LOW POWER CMOS NE555V TIMER

AMENDMENTS TO LEAFLETS

FIG.11.

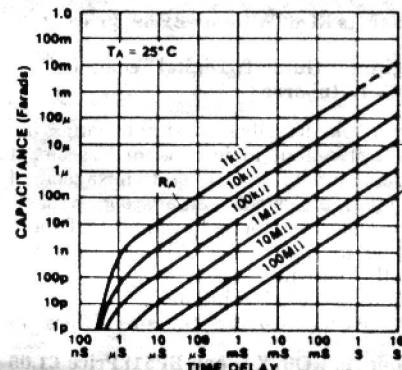
Fig 11 is incorrect; it is shown correctly above.
